Access Compliance Report

Public Rights-of-Way

(Curb Ramps)

Intersection ID: 19137	Main Street: CLIFTON_MEADOW_DR	Cross Street: OLD_GATE_DR	Location: NW
ADA ID: 9B165FEE65EB	Ramp Type: PerpDiag	Initial Pass/Fail: Fail	Overall Compliance: No
Severity Score: 46.25			
Codes/Mitigation Info/Possible Solution		Field Measurements/Component Compliance

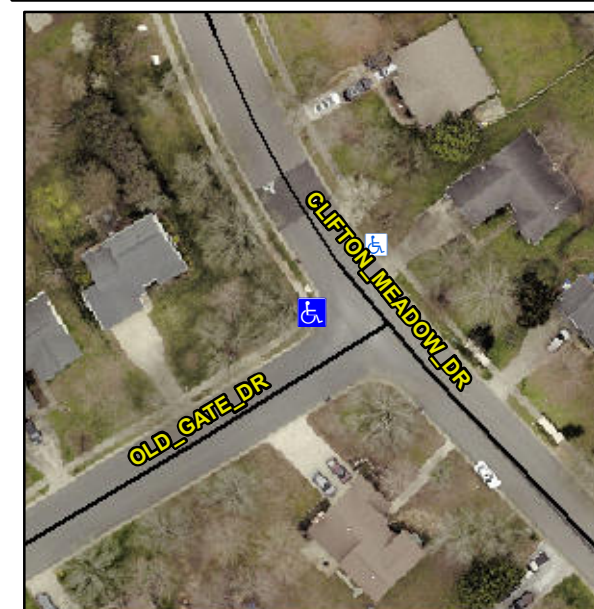
Not Found, R304.5.1, R304.2.2, R304.5.3

Compliance	Description	Data	Compliance	Description	Data
N/A	Ramp Length (in)	46.5	No	Ramp Slope (%)	8.6
No	Ramp Width (in)	47.0	No	Ramp XSlope (%)	7.2
N/A	Flare Type LT	N/A	N/A	Flare Type RT	N/A
N/A	Flare Slope LT (%)	N/A	N/A	Flare Slope RT (%)	N/A
N/A	Flare Traversable LT?	N/A	N/A	Flare Traversable RT?	N/A
N/A	Landing Length (in)	N/A	N/A	DWS Provided?	N/A
N/A	Landing Width (in)	N/A	N/A	DWS Contrast?	N/A
N/A	Landing Slope (%)	N/A	N/A	DWS Length (in)	N/A
N/A	Landing X Slope (%)	N/A	N/A	DWS Full Width?	N/A
N/A	Landing Curb? (Y/N)	N/A	N/A	DWS Offset (in)	N/A
N/A	Shared Landing?	N/A			
N/A	Gutter Ponding?	N/A	N/A	Gutter Slope (%)	N/A
N/A	Gutter Lip Ht (in)	N/A	N/A	Gutter X Slope (%)	N/A
N/A	Painted X Walk1?	No	N/A	Painted X Walk2?	No
	X Walk 1 Direction	To SE		X Walk 2 Direction	To NE
N/A	X Walk 1 Width (in)	N/A	N/A	X Walk 2 Width (in)	N/A
	X Walk 1 Slope (%)	2.9		X Walk 2 Slope (%)	0.1
	X Walk 1 X Slope (%)	3.2		X Walk 2 X Slope (%)	2.8

Remove & Replace Curb Ramp With Two New Directional Ramps or Equivalent.
